ADDENDUM NO. 1
March 4, 2024

FIRE STATION # 1
City of Marion
Marion, AR 72364

The following changes, clarifications, additions or deletions shall be made a part of the Contract Documents.

Drawing Number: S2.1	
Date: September 29, 2023	Project Number: 22207

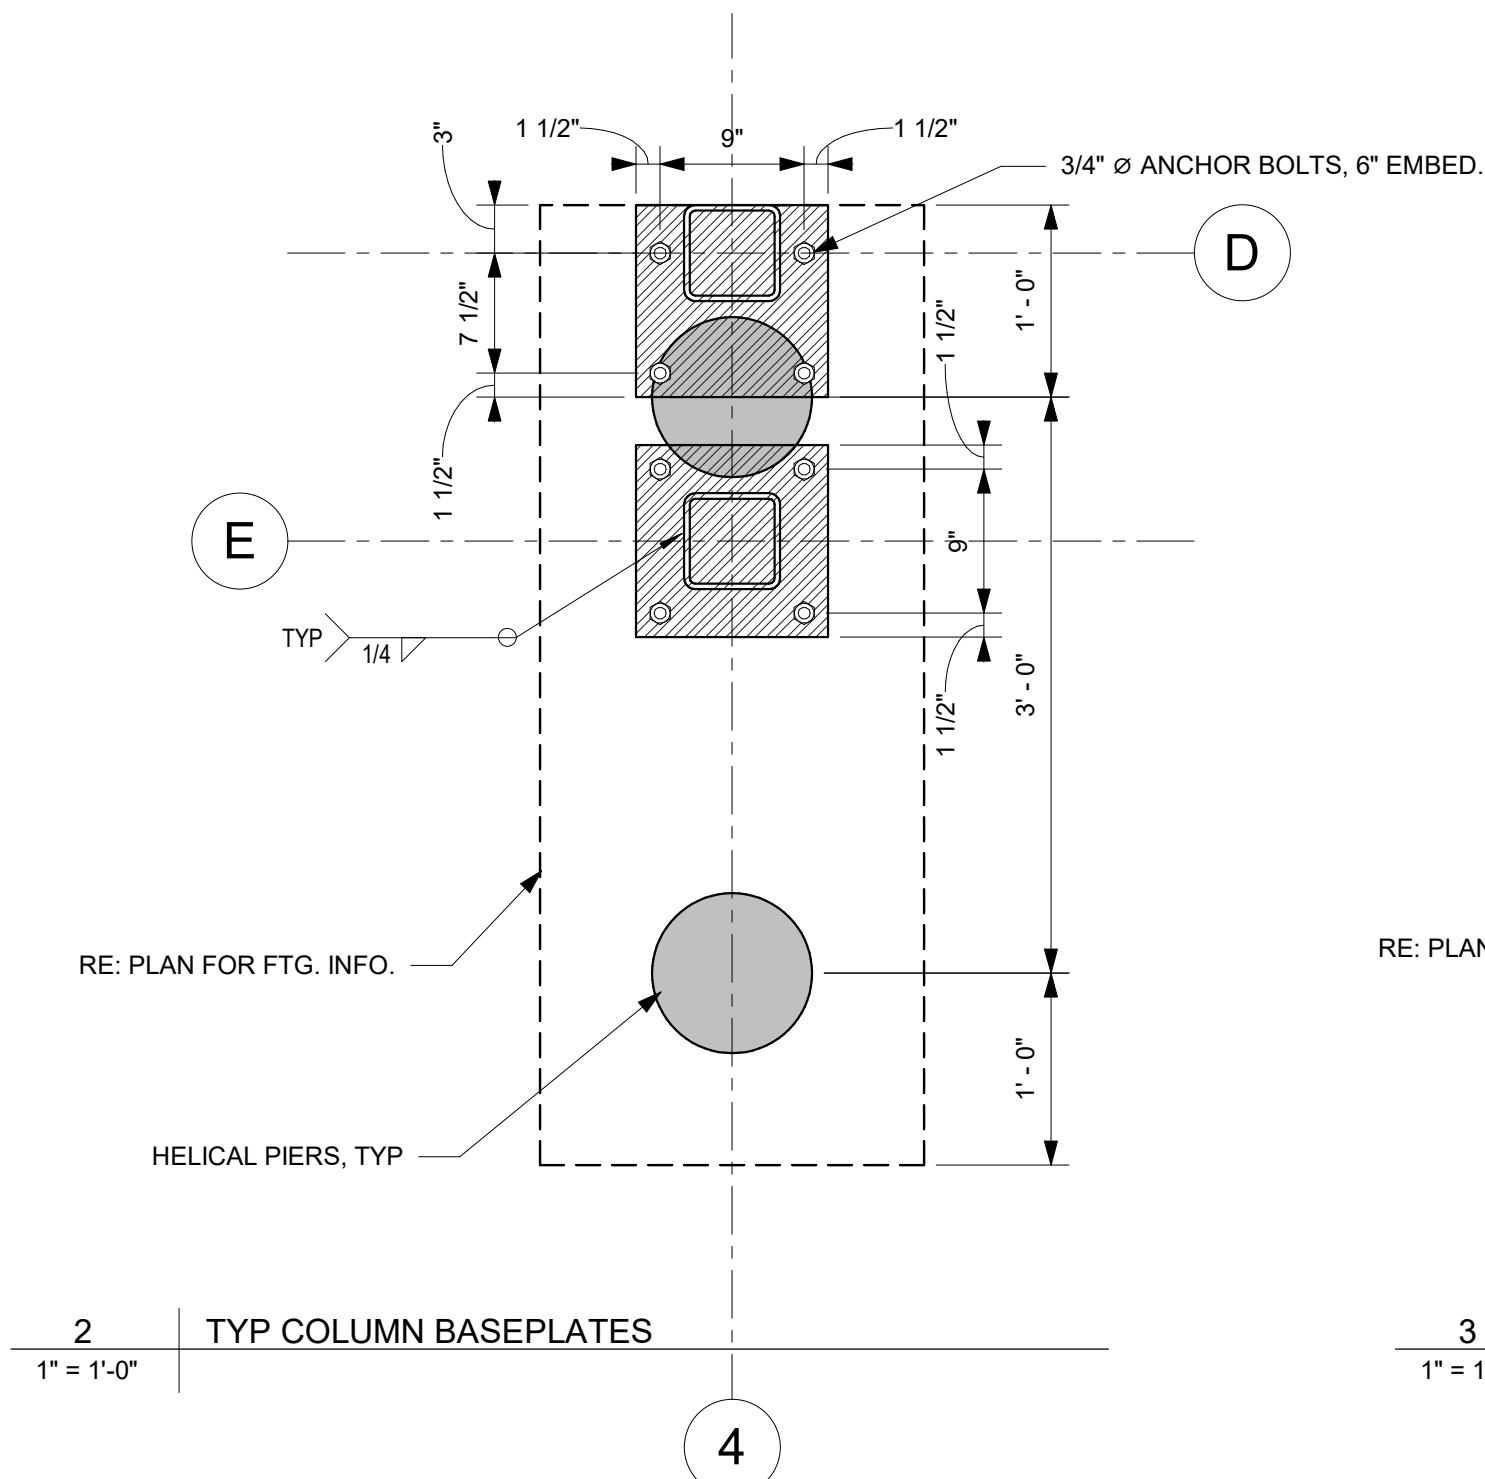
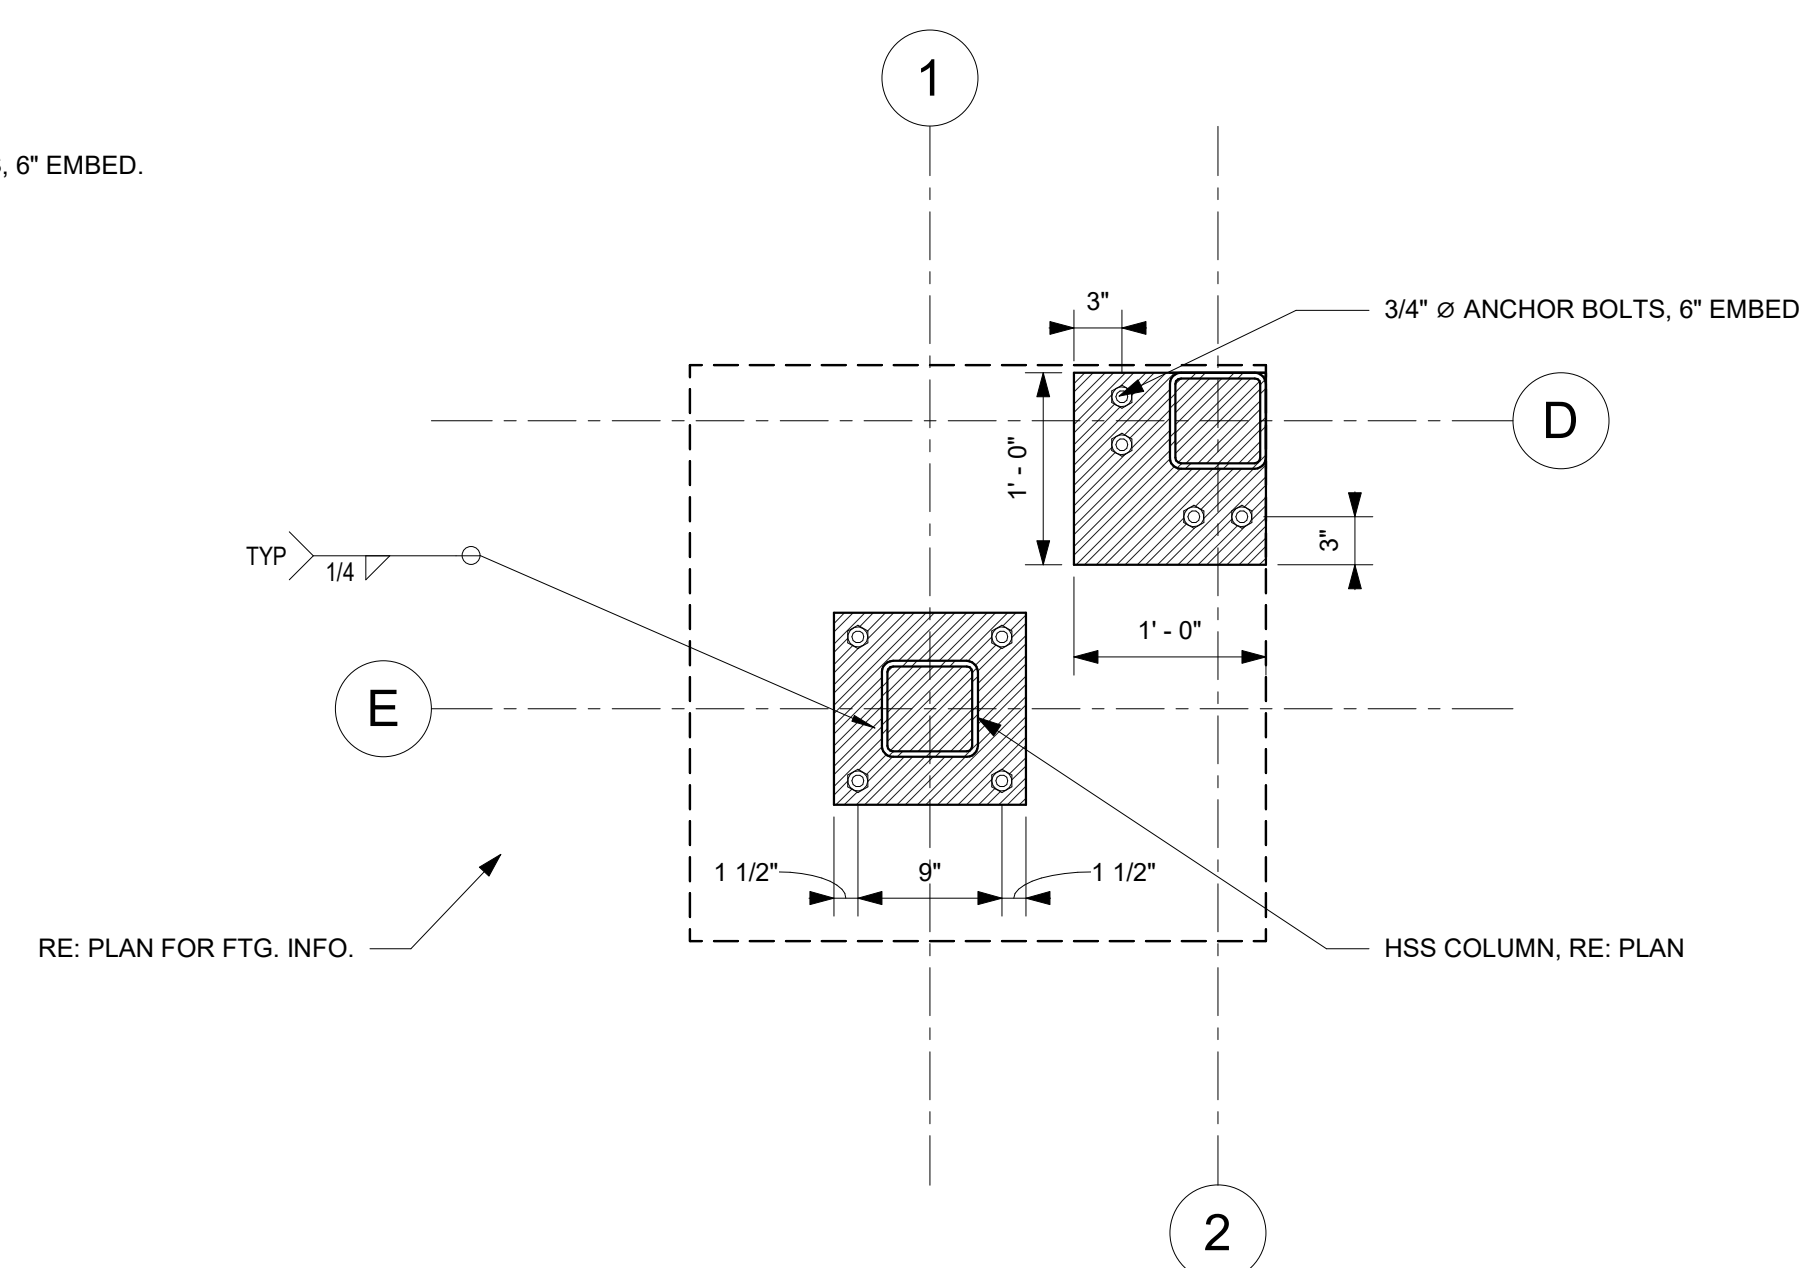
S2.1 Revised structural column locations, added gridlines and dimensions for clarification.

FLOOR PLAN - LIGHTING
Drawing Number:
E1.1
Date: September 29, 2023
Project Number: 22207

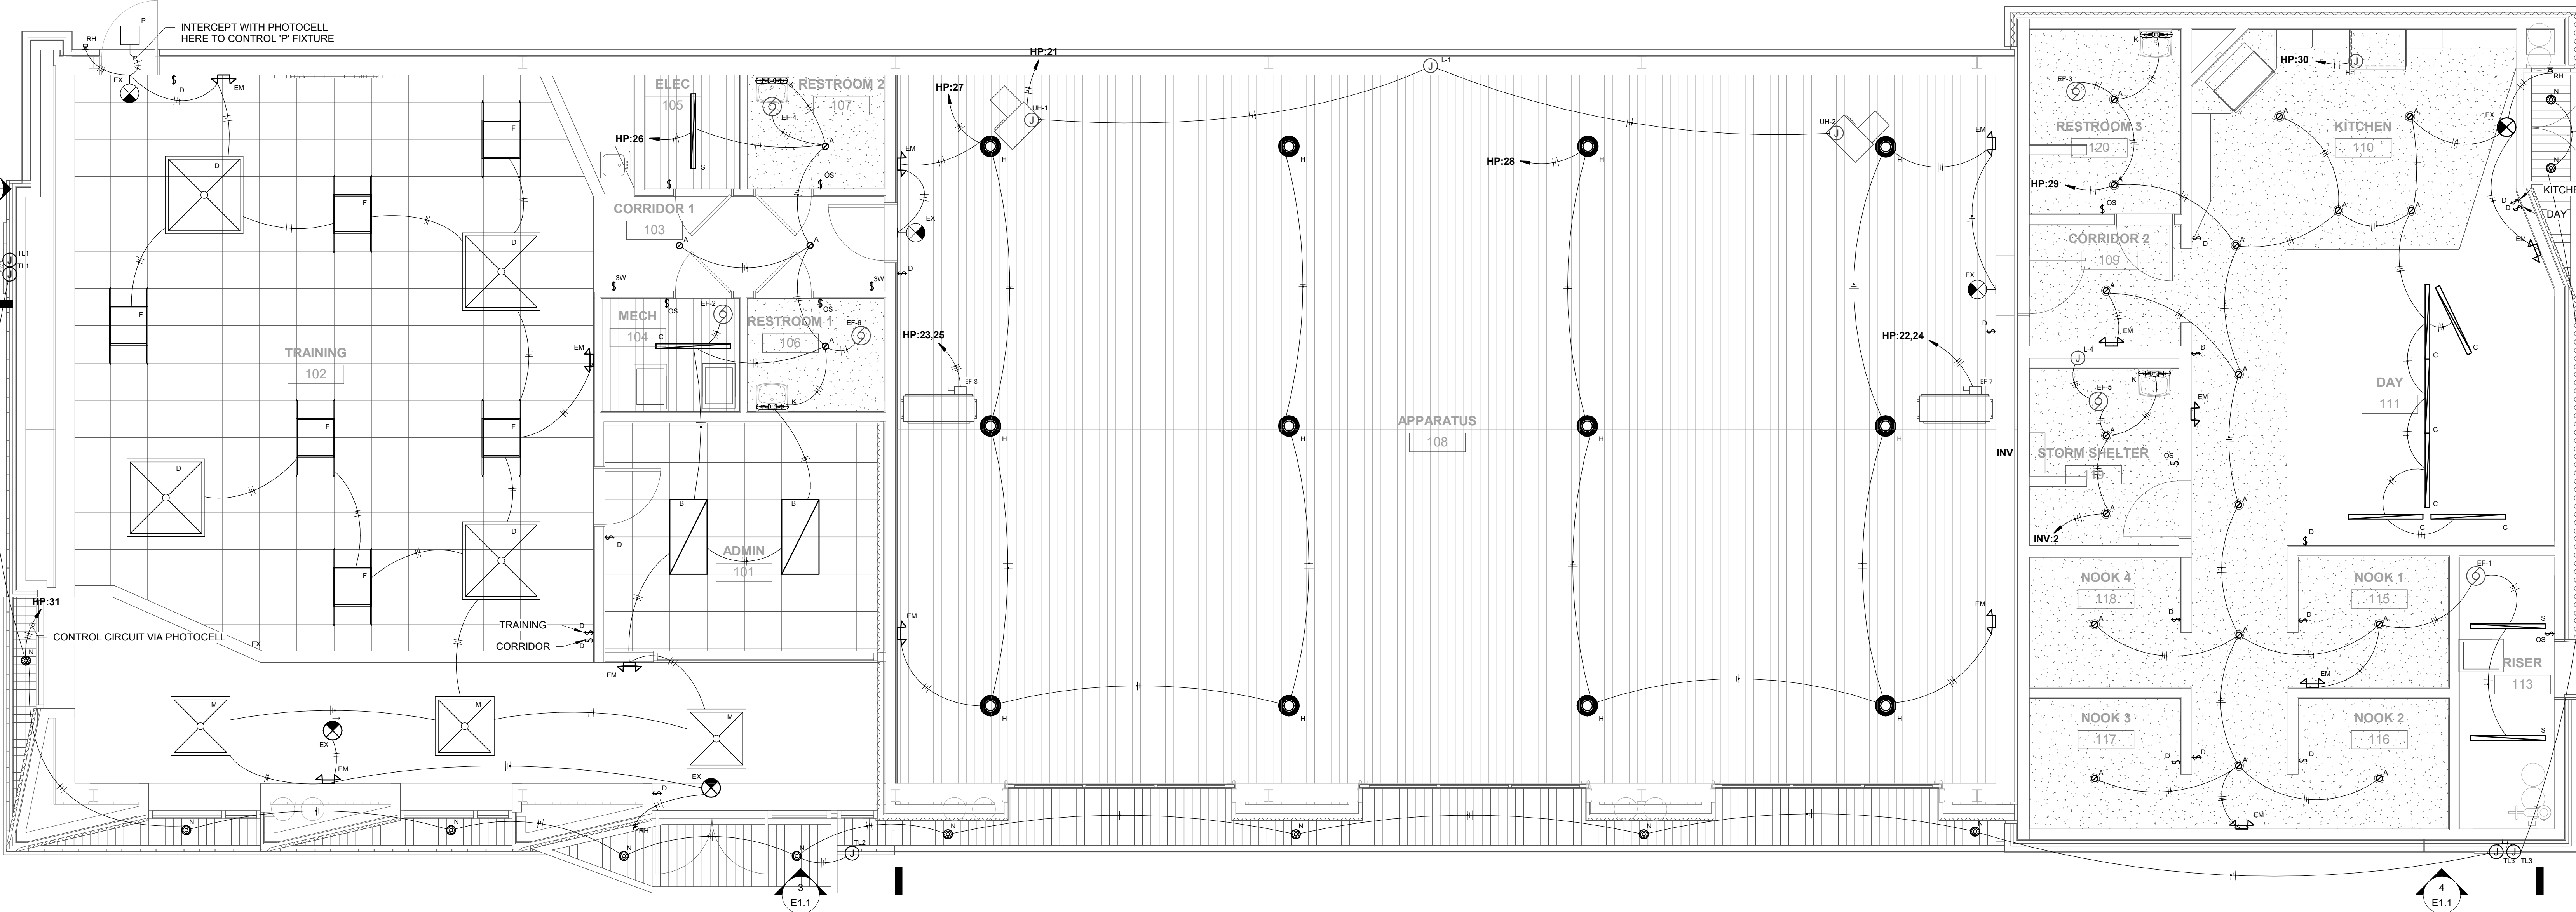
E1.1 Revised Lighting Fixture Schedule to show standard light pole in lieu of hinged light pole at "P30" fixtures.

P1.1

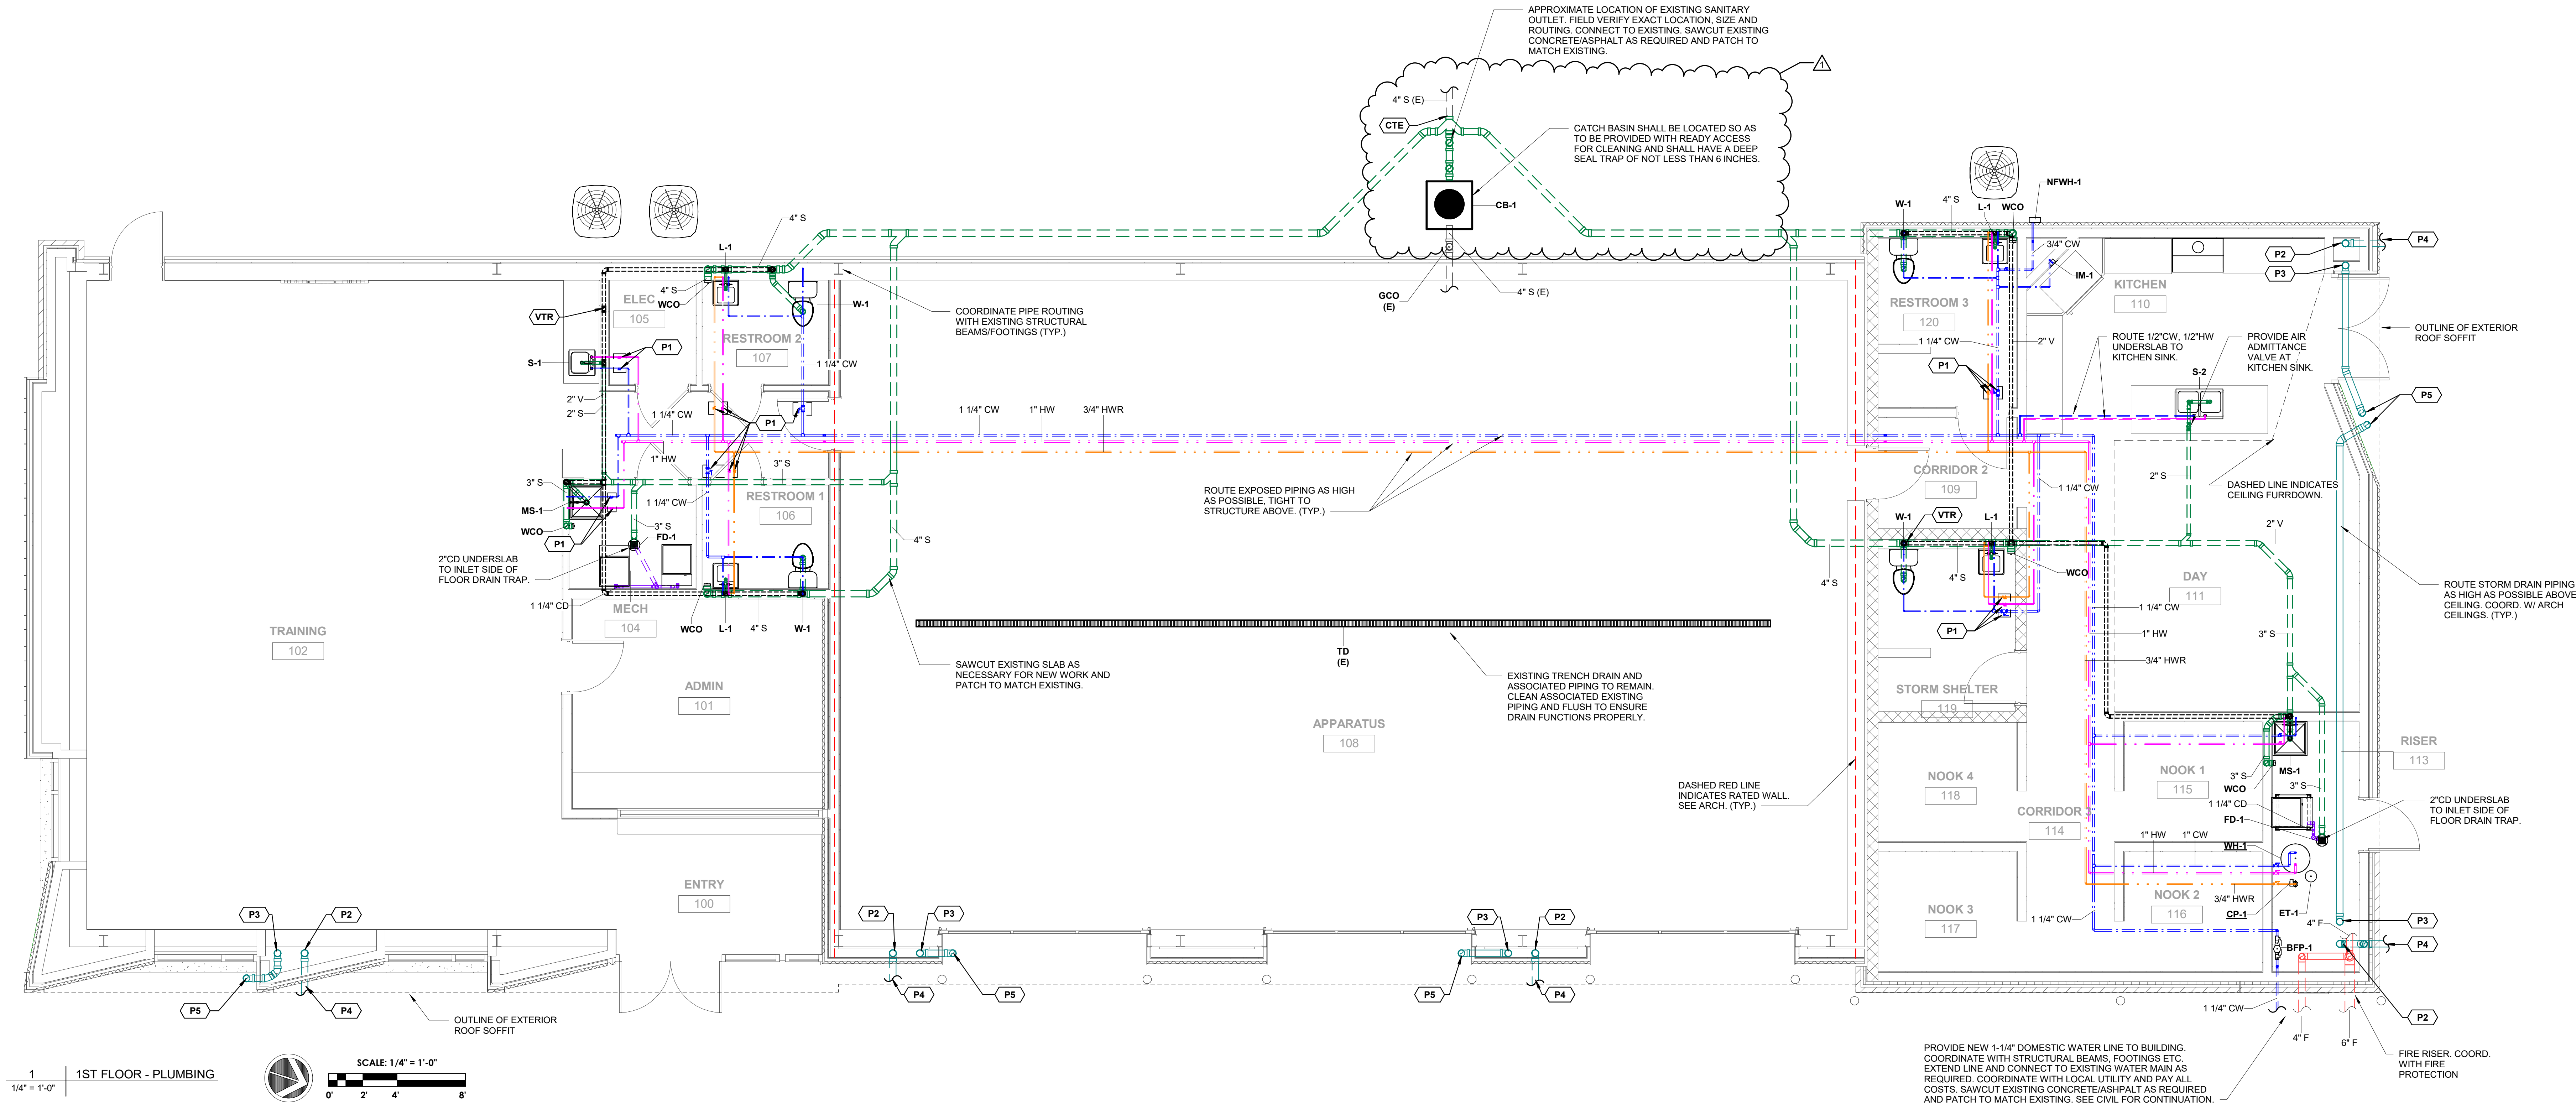
Reference Drawings, Revisions dated 2-29-24 for sheets M1.2 and P1.1; Sheet M1.2, to clarify the type of control damper for the storm shelter and P1.1 adding a sand interceptor.
